Product Change Notice (PCN)

PCN Number: PCN-0450036R-01

Product(s) Affected: MD-S series (part numbers MD-40S, MD-60S, MD-70S, MD-80S, MD-90S).

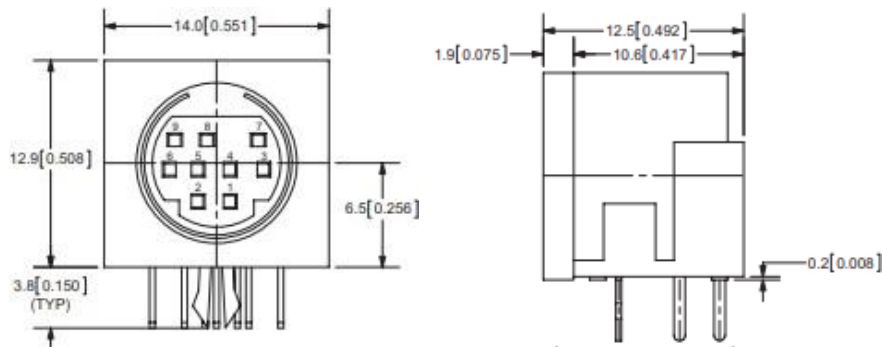
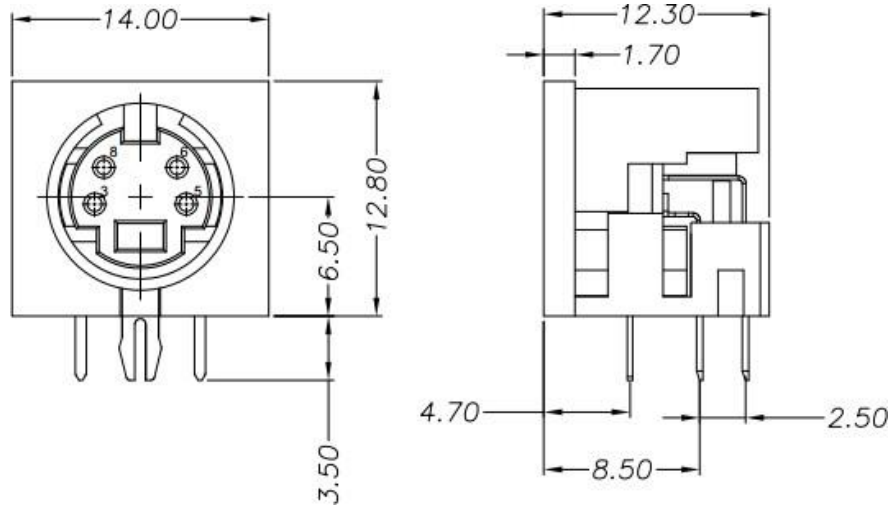
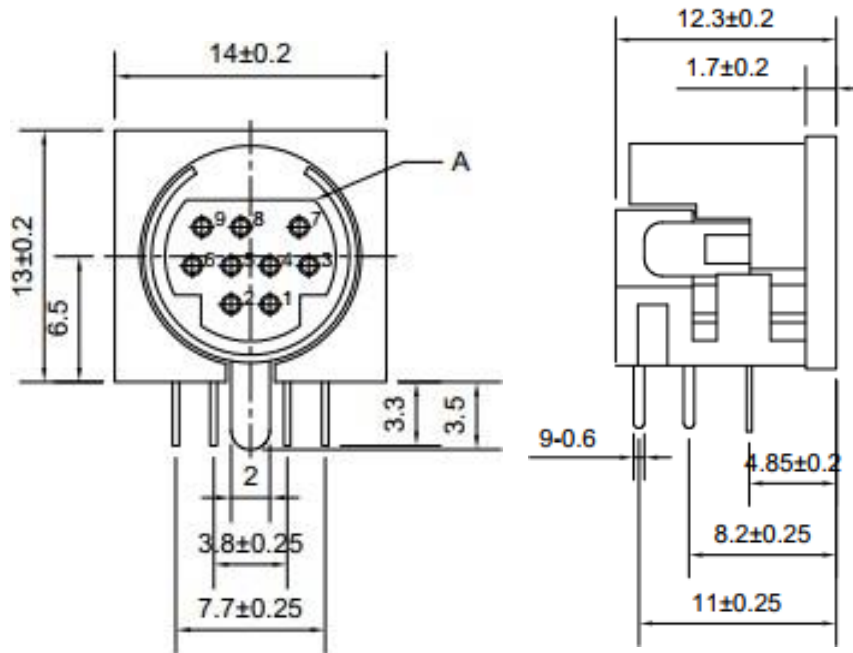
Description of Change: minor dimensional changes, such as pin length, and materials changes, as shown below.
